RE: Assistant Commissioner's Decision in the Matter of the Minnesota Technical Reference Manual Version 5.0

Docket No. E,G999/CIP-18-694

Minnesota Technical Reference Manual Version 5.0.

Figure 2: MN Statewide and Regional Furnace Market Share by AFUE Category (2013-2016)

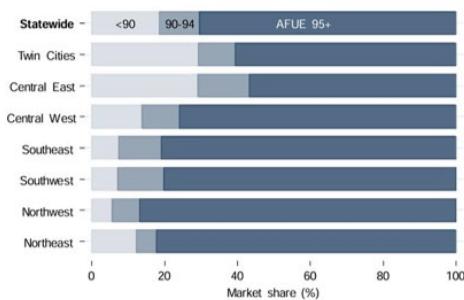
The 2018 ECO Potential Study found that less than 20 percent of furnaces sold in Minnesota between 2013 and 2016 had an AFUE less than 90 percent.

Figure 4
Regional Distribution of HES Visits

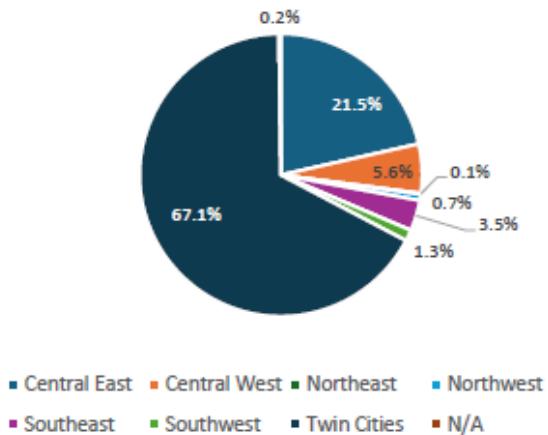
Table 1 and Figure 4 show the regional distribution of the HES visits, with 67.1 percent of visits occurring in Hennepin and Ramsey counties (the Twin Cities region) and 21.5 percent of visits occurring in the Central East region.⁷¹

Figure 5

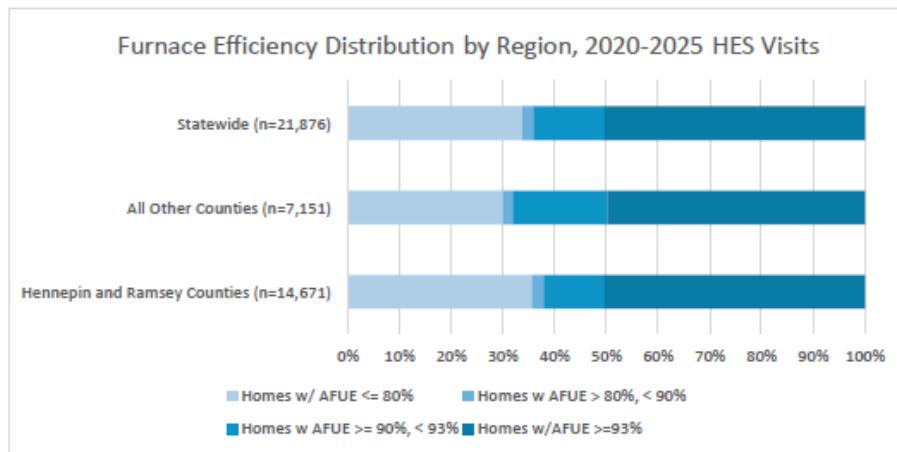
CEE also grouped the furnace efficiencies into broader efficiency ranges, as shown in Table 2 and Figure 5. The percent of furnaces that fell within each range of efficiency are reported in three geographic categories: 1) Statewide, 2) Hennepin and Ramsey Counties, and 3) All Other Counties excluding Hennepin and Ramsey. There were 54 HES visits in the dataset with no recorded county which were included in the Statewide category but excluded from the Hennepin and Ramsey Counties and All Other Counties categories.

Although the HES data disproportionately represents homes in the Twin Cities and Central East regions, as shown above in Figure 5, the Twin Cities region appears to have a higher proportion of furnaces with AFUEs below 90 percent compared to the rest of the state. The 2018 ECO Potential Study sales data similarly found that the Twin Cities and Central East regions had the highest share of furnaces with AFUEs lower than 90 percent.

Figure 6

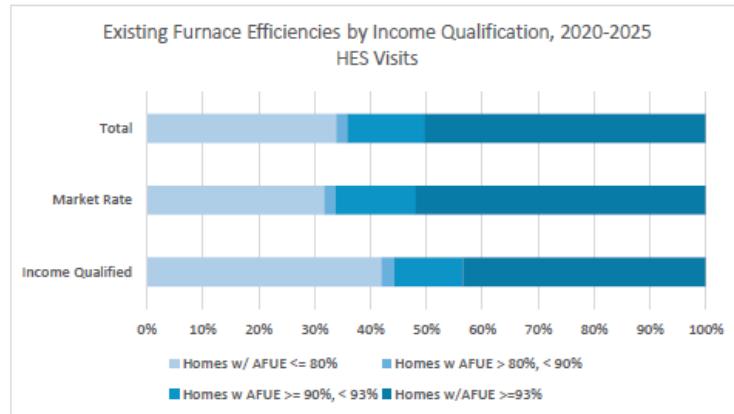
To explore differences between the income qualified and market rate segments, CEE categorized the AFUEs for each into broader ranges of efficiency, as shown in Table 3 and Figure 6.

About 44 percent of the furnace AFUEs recorded for income qualified households were less than 90 percent, compared to 34 percent of the AFUEs recorded for market rate customers. The average AFUE for income qualified households was about 87.9 percent, which was lower than the average AFUE for market rate households, which was about 89.2 percent. This suggests that income qualified households may be more likely to have a low efficiency furnace, which aligns with the Focus in Energy study finding that Wisconsin contractors offered a lower average AFUE to low-income customers than to market rate customers.
